Access Compliance Report

Public Rights-of-Way

(Curb Ramps)

Intersection ID: 50272	Main Street: SOUTH_BV	Cross Street: WHITTON_ST	Location: SE
ADA ID: 06C1CF23237A	Ramp Type: Perp	Initial Pass/Fail: Fail	Overall Compliance: No
Severity Score: 22.5			
Codes/Mitigation Info/Possible Solution		Field Measurements/Component Compliance

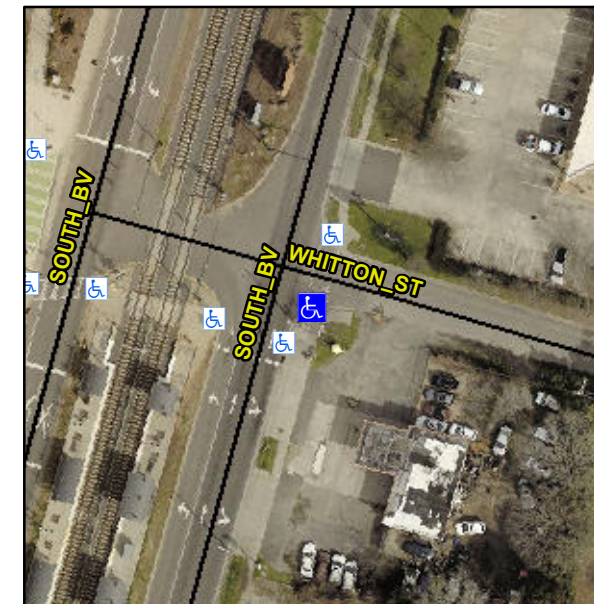
Not Found, R304.5.1, R304.2.2

Compliance	Description	Data	Compliance	Description	Data
N/A	Ramp Length (in)	86.0	No	Ramp Slope (%)	8.7
No	Ramp Width (in)	47.0	Yes	Ramp XSlope (%)	3.6
N/A	Flare Type LT	N/A	N/A	Flare Type RT	N/A
N/A	Flare Slope LT (%)	N/A	N/A	Flare Slope RT (%)	N/A
N/A	Flare Traversable LT?	N/A	N/A	Flare Traversable RT?	N/A
N/A	Landing Length (in)	N/A	N/A	DWS Provided?	N/A
N/A	Landing Width (in)	N/A	N/A	DWS Contrast?	N/A
N/A	Landing Slope (%)	N/A	N/A	DWS Length (in)	N/A
N/A	Landing X Slope (%)	N/A	N/A	DWS Full Width?	N/A
N/A	Landing Curb? (Y/N)	N/A	N/A	DWS Offset (in)	N/A
N/A	Shared Landing?	N/A			
N/A	Gutter Ponding?	N/A	N/A	Gutter Slope (%)	N/A
N/A	Gutter Lip Ht (in)	N/A	N/A	Gutter X Slope (%)	N/A
N/A	Painted X Walk1?	Yes	N/A	Painted X Walk2?	N/A
	X Walk 1 Direction	To NE		X Walk 2 Direction	N/A
N/A	X Walk 1 Width (in)	111.0	N/A	X Walk 2 Width (in)	N/A
	X Walk 1 Slope (%)	1.0		X Walk 2 Slope (%)	N/A
	X Walk 1 X Slope (%)	3.8		X Walk 2 X Slope (%)	N/A

N/A	Ramp inside XWalk1?	Yes	N/A	Ramp inside XWalk2?	N/A
	Road Slope (%)	N/A	N/A	Clear Space?	N/A
	Road X Slope (%)	N/A	N/A	Clear Space to XWalk (in)	N/A
N/A	Any Obstructions?	N/A	N/A	Storm Grate/Utility Hazard?	N/A
	Obstruction Type			Storm Grate/Utility Type	
		N/A			N/A
			Yes	Surface Condition? (G/P)	Good

Remove & Replace Entire Ramp.
